WINDOW & DOOR REPLACEMENT

**ABRAHAM BALDWIN MIDDLE SCHOOL
68 BULLARD DRIVE
GUILFORD, CT 06437
BID NO. 11-1617
STATE PROJECT #060-0102 EC**

Date Issued: March 16, 2017

End of Addendum '3'

ABRAHAM BALDWIN MIDDLE SCHOOL
 PCB SOILS EXCAVATION - EXISTING LOWER LEVEL
 68 BULLARD DRIVE
 GUILFORD, CONNECTICUT

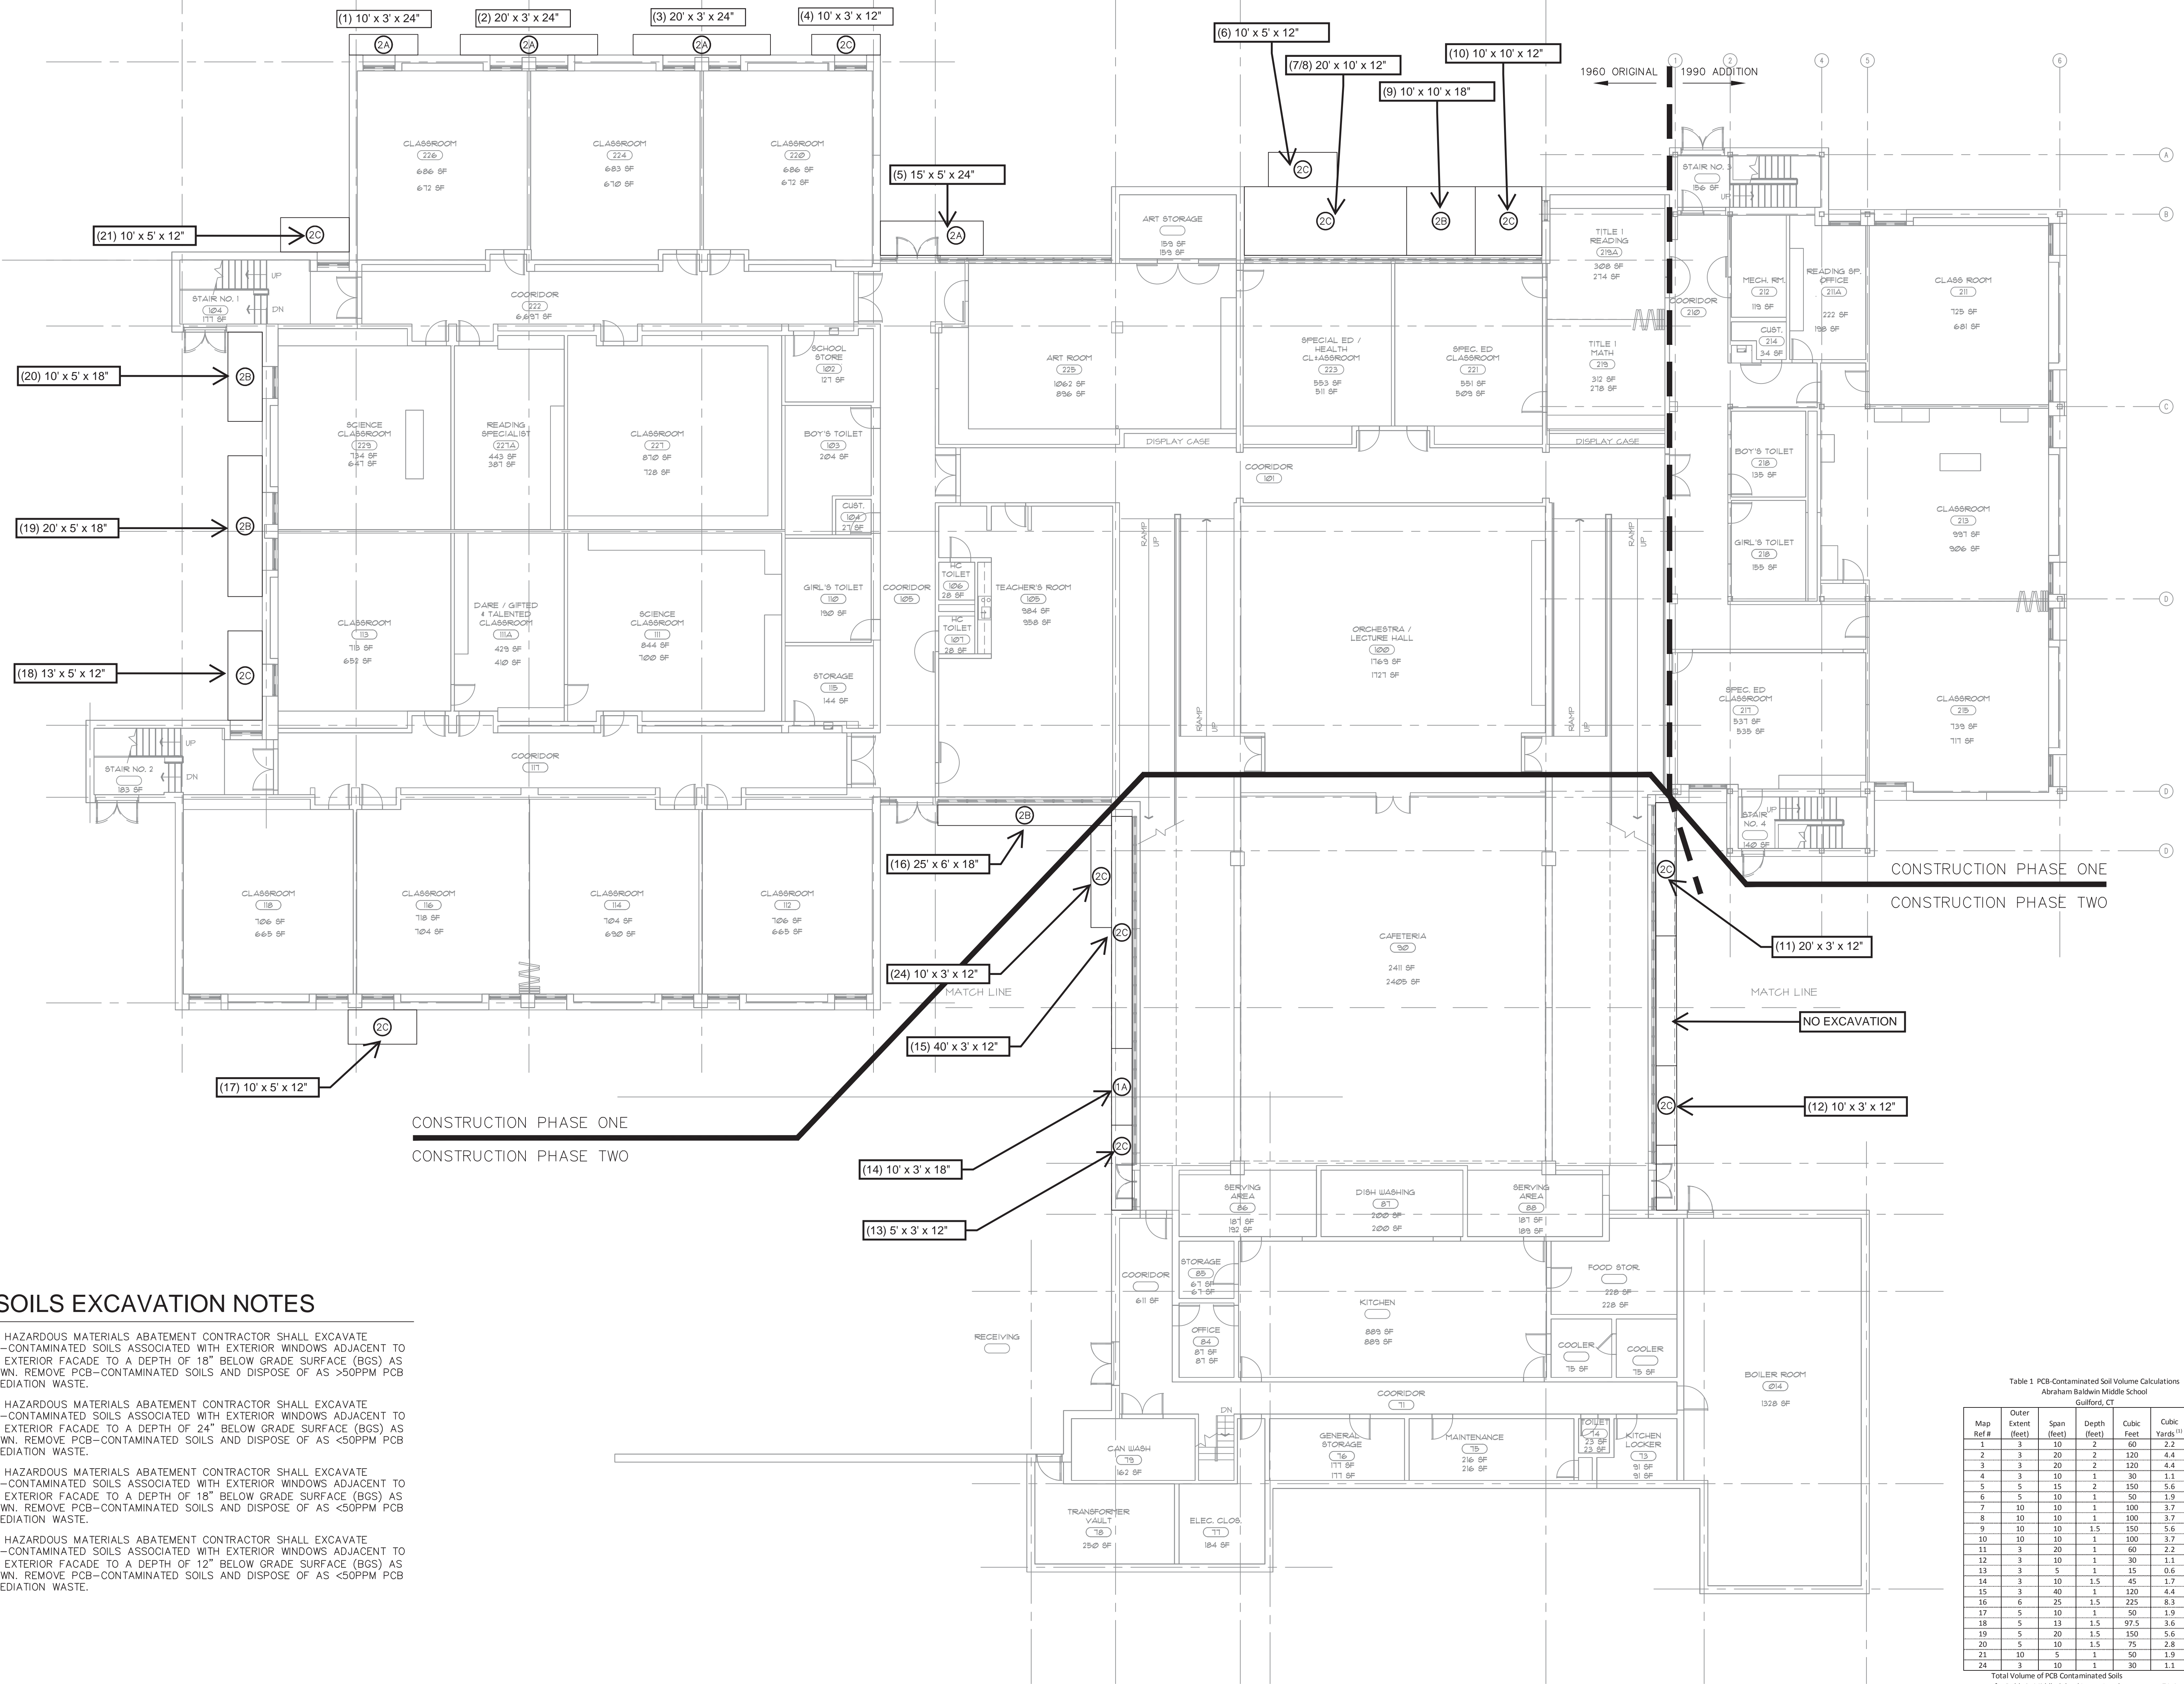
- SECTION 028434, POLYCHLORINATED BIPHENYL BULK PRODUCT ABATEMENT, Page 6, Article 1.10.C., Base Bid – PCB Remediation Waste, Estimated Quantity, revise “117 Cubic Yards” to read “See Table 1 PCB-Contaminated Soil Volume Calculations on Drawings HS-01 & HS-02”.

“All testing of suspected hazardous material is by Owner. All abatement of confirmed hazardous material is by Contractor. Coordinate with all demolition work. This includes but is not limited to all paints, caulk, and sealants.”
- The following ABATEMENT drawings are being deleted in their entirety. New drawings (2) have been added and are attached as part of this addendum*:
 - HS-01 PCB SOILS EXCAVATION EXISTING LOWER LEVEL
 - HS-02 PCB SOILS EXCAVATION EXISTING UPPER LEVEL

- (1A) THE HAZARDOUS MATERIALS ABATEMENT CONTRACTOR SHALL EXCAVATE PCB-CONTAMINATED SOILS ASSOCIATED WITH EXTERIOR WINDOWS ADJACENT TO THE EXTERIOR FACADE TO A DEPTH OF 18" BELOW GRADE SURFACE (BGS) AS SHOWN. REMOVE PCB-CONTAMINATED SOILS AND DISPOSE OF AS >50PPM PCB REMEDIATION WASTE.

- (2A) THE HAZARDOUS MATERIALS ABATEMENT CONTRACTOR SHALL EXCAVATE PCB-CONTAMINATED SOILS ASSOCIATED WITH EXTERIOR WINDOWS ADJACENT TO THE EXTERIOR FACADE TO A DEPTH OF 24" BELOW GRADE SURFACE (BGS) AS SHOWN. REMOVE PCB-CONTAMINATED SOILS AND DISPOSE OF AS <50PPM PCB REMEDIATION WASTE.

- (2B) THE HAZARDOUS MATERIALS ABATEMENT CONTRACTOR SHALL EXCAVATE PCB-CONTAMINATED SOILS ASSOCIATED WITH EXTERIOR WINDOWS ADJACENT TO THE EXTERIOR FACADE TO A DEPTH OF 18" BELOW GRADE SURFACE (BGS) AS SHOWN. REMOVE PCB-CONTAMINATED SOILS AND DISPOSE OF AS <50PPM PCB REMEDIATION WASTE.

- (2C) THE HAZARDOUS MATERIALS ABATEMENT CONTRACTOR SHALL EXCAVATE PCB-CONTAMINATED SOILS ASSOCIATED WITH EXTERIOR WINDOWS ADJACENT TO THE EXTERIOR FACADE TO A DEPTH OF 12" BELOW GRADE SURFACE (BGS) AS SHOWN. REMOVE PCB-CONTAMINATED SOILS AND DISPOSE OF AS <50PPM PCB REMEDIATION WASTE.
